TREATABILITY STUDY WORK PLAN FOR ZERO
VALENCE IRON CONTINUOUS REACTIVE WALL
AT THE ASH LANDFILL

FEBRUARY 1999

**SENECA ARMY DEPOT ACTIVITY
ROMULUS, NEW YORK**

**Response to the EPA Comments on the Treatability Study Work Plan for Zero Valence
Iron Continuous Reactive Wall at the Ash Landfill
Comments dated January 22, 1999**

FIGURE 1
 ASH LANDFILL SITE MAP WITH VOLATILE ORGANICS PLUME: POST-REMOVAL ACTION CONDITIONS

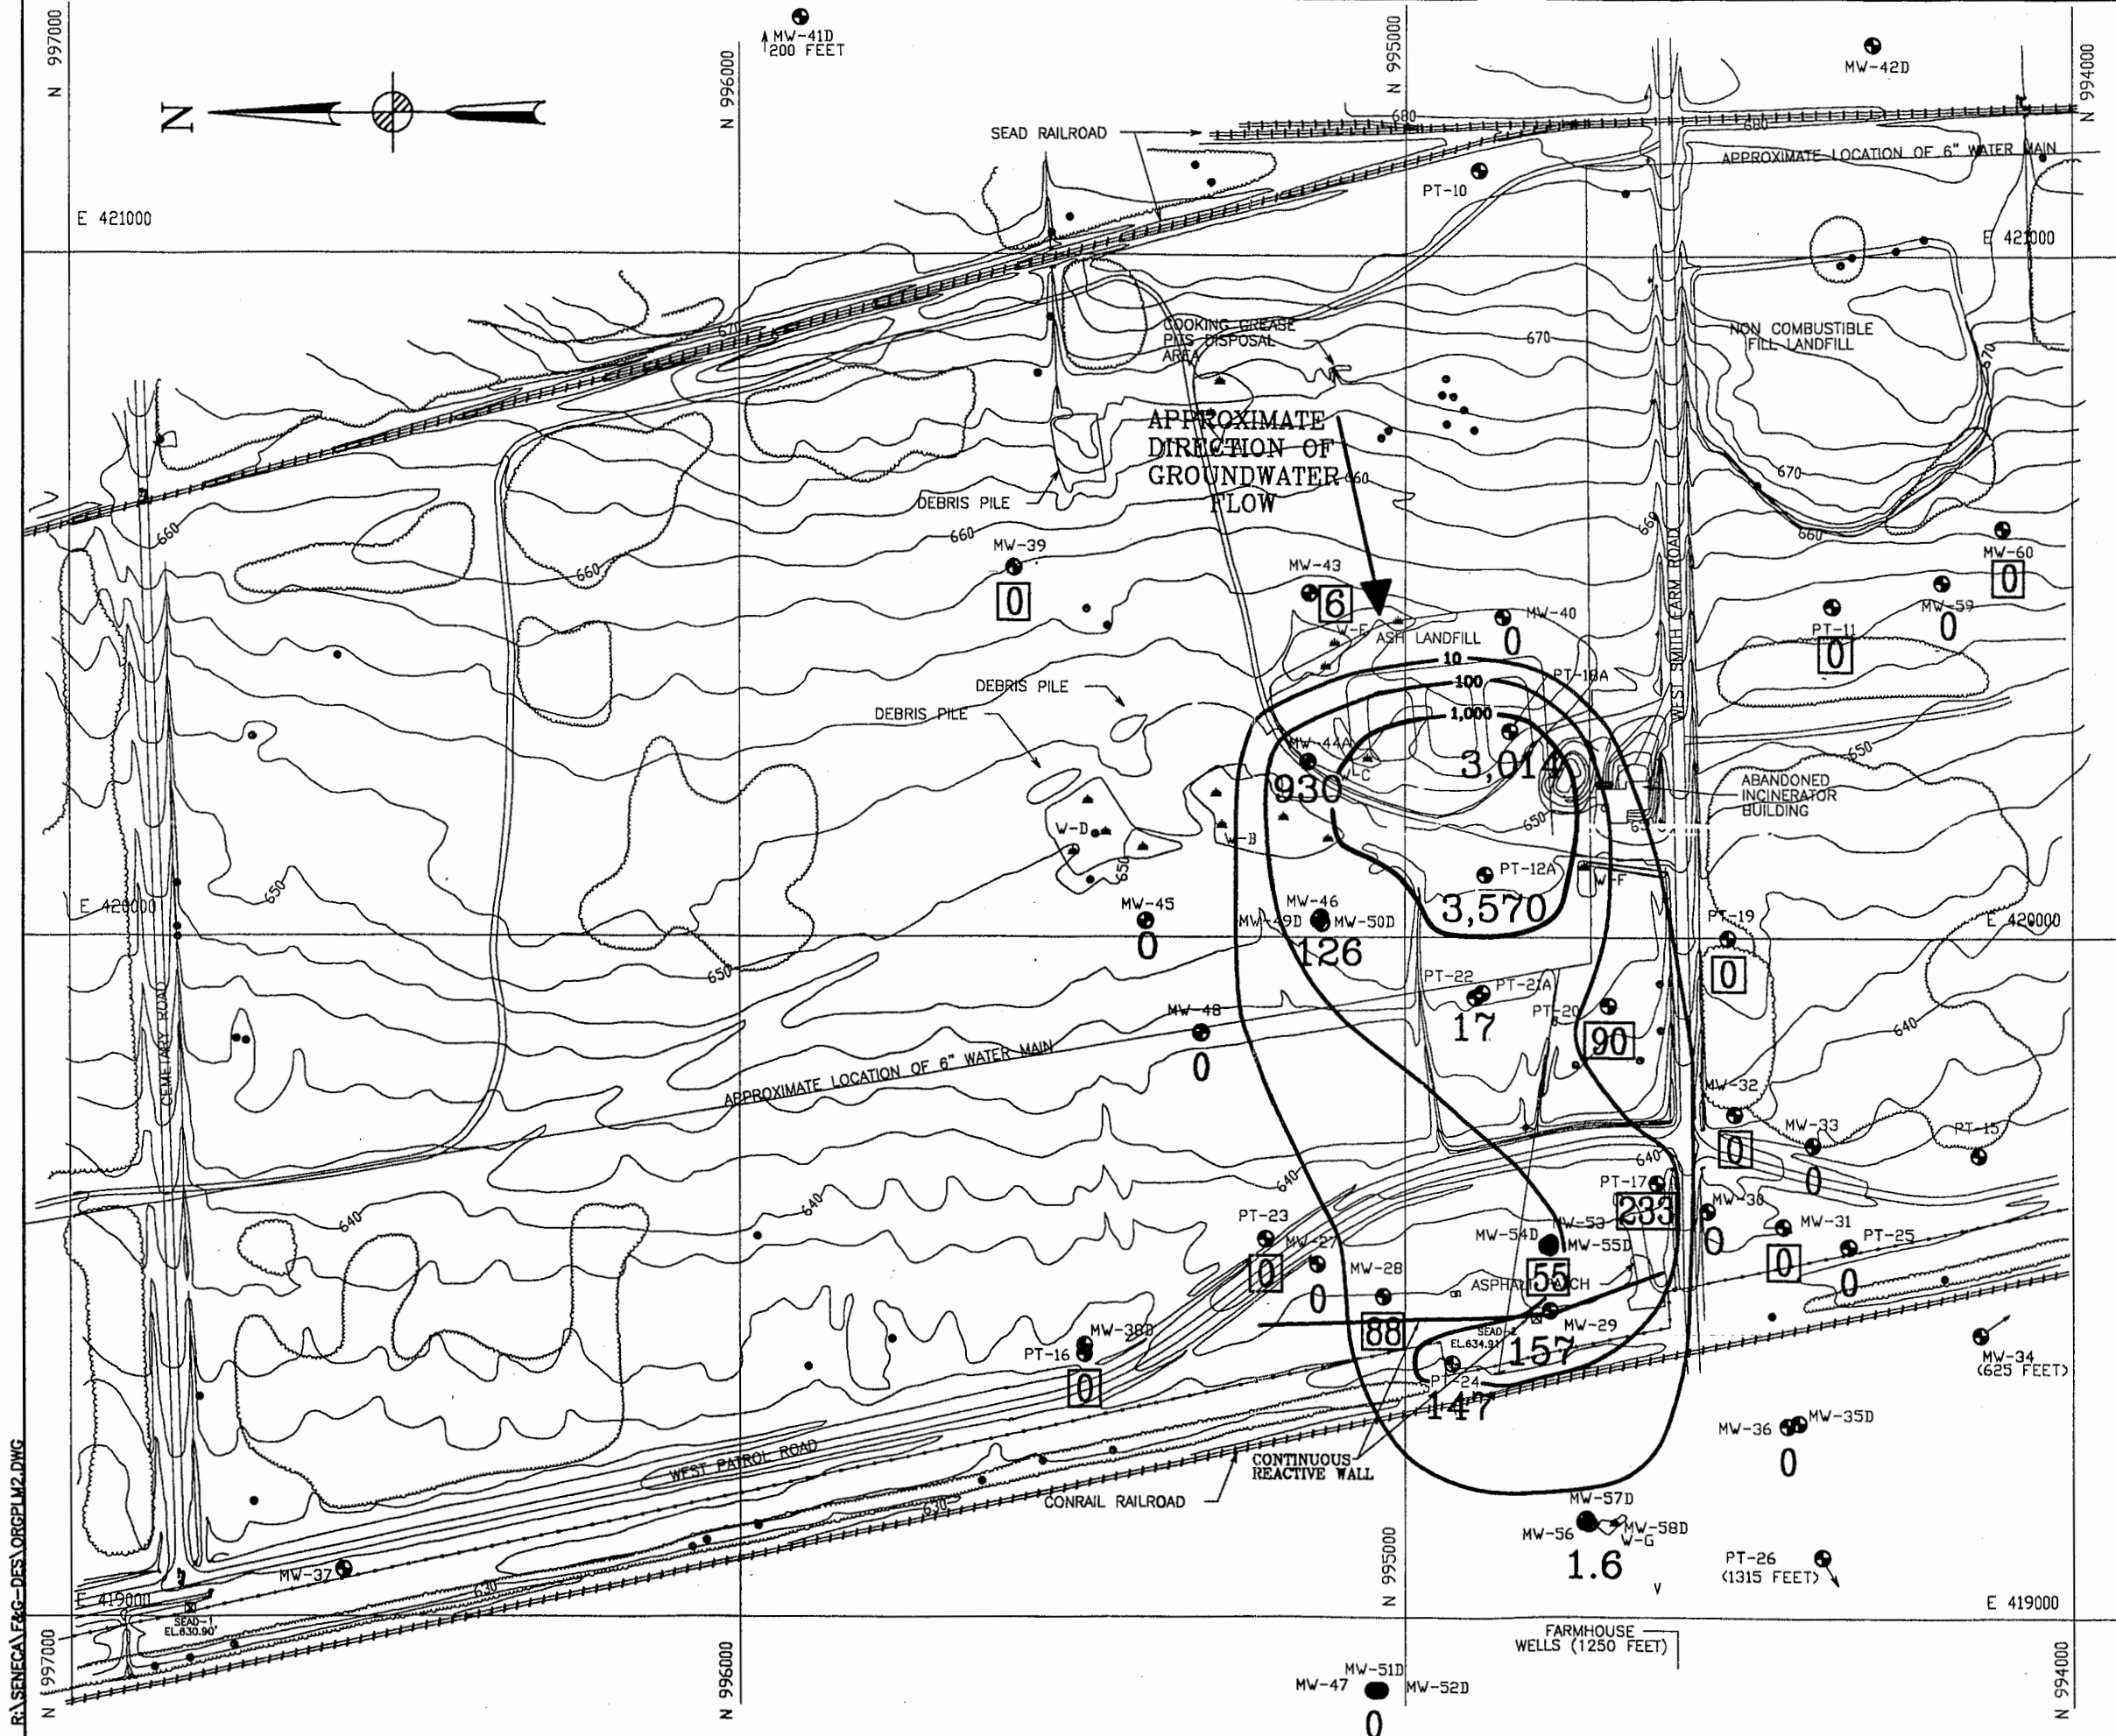
Page 4, Section 2.3: The text in this section states that MW-44 is located in the source area, however, a review of Figure 1 shows that there is no MW-44 in the plume, but there is a MW-44A. Text should be added to the document explaining which well is being discussed. The text in this paragraph also states that VOCs range from 10 ug/L to 100 ug/L; however, a review of Figure 1 shows a maximum concentration of 157 ug/L. The text should be corrected to reflect this maximum concentration.

Page 7, Section 5.1, p2: The purpose of MW-T8, i.e., to monitor for migration of contamination around the reactive wall, will be compromised because the well is located within the plume which is shown on Figure 1. Based on this, the wall should be extended further to the south, and should extend to a point almost directly west of monitoring well MW-30.

Figure 1: The reactive wall presented in this figure does not extend through the width of the plume, the wall should be extended to the south to capture and treat the plume.

Response: Agreed. MW-44 was located in the source area before the removal action took place at the Ash Landfill. The concentrations referenced in this section from MW-44 were detected prior to the removal action. Since MW-44 was located in the source area which was removed, MW-44 was removed and later replaced with MW-44A in the same location. The text has been modified to clarify that MW-44, the monitoring well from which the referenced data were collected, was located where MW-44A currently exists in Figure 1.

Response: The plume contour lines on Figure 1 may not accurately reflect the southern extent of the plume due to the presence of West Smith Farm Road. Contour lines indicate estimated concentrations based on the groundwater monitoring data shown and do not take into account the physical barrier that West Smith Farm Road may be providing as well as the topographic high point of competent shale which was observed to occur near this road during construction (based on trench bottom topography - see Figure G-1 attached). As we discussed during our conference call on December 8, 1998, except for MW-30, there is no evidence that the plume has migrated across this road. As USEPA pointed out, there have been occasional detections of TCE in MW-30 at concentrations hovering above the detection limit and below NYSDEC GA Standards. These detections have not been consistent. Because we are not convinced that the plume extends across the road, it was decided not to extend the wall across this road. Monitoring well MW-T11 (previously called MW-T8 in the earlier version of the treatability study work plan) will be located in the road at the southern end of the trench. If chlorinated solvents are detected in this well, the final remedy at the site will need to address this extension of the plume. However, for the purposes of this treatability study, monitoring from this well will occur before further action is taken.

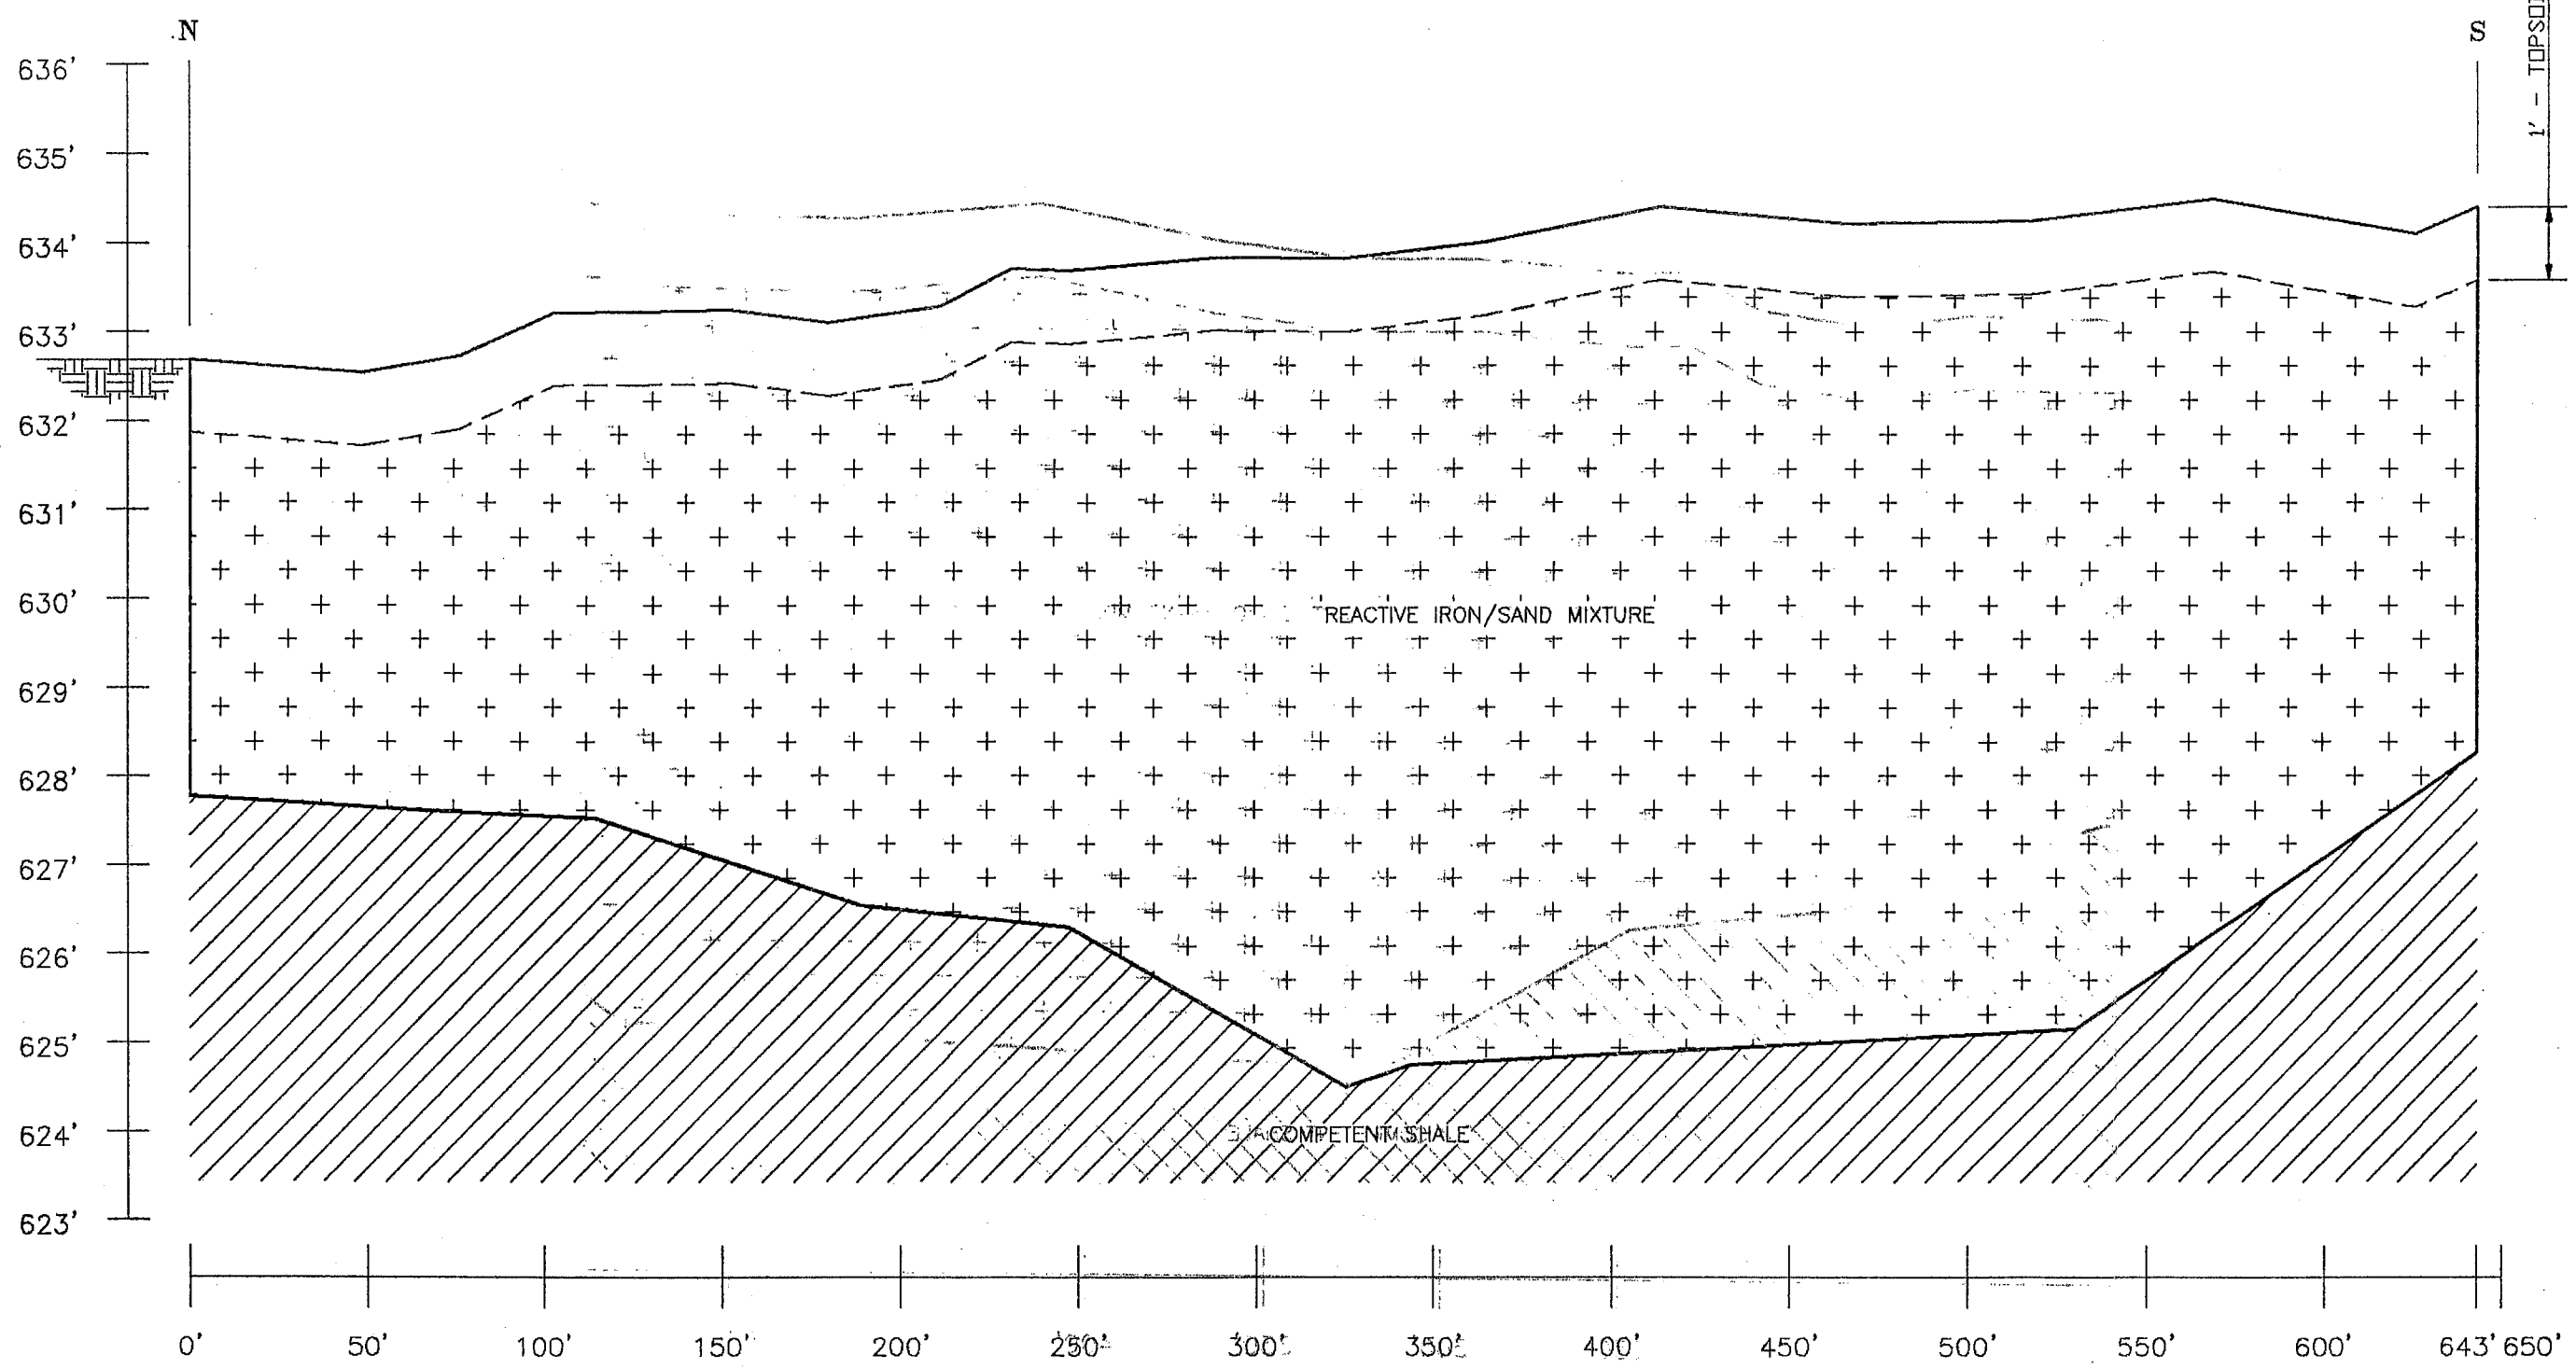
Appendix B, Figure 6: As the design calls for a continuous reactive wall treatment trench, this figure is mislabeled "Cross Section, Funnel System", and Figure 7 is mislabeled as "Reactive Gate".

Response: Agreed. Figures 6 and 7 are mislabeled.
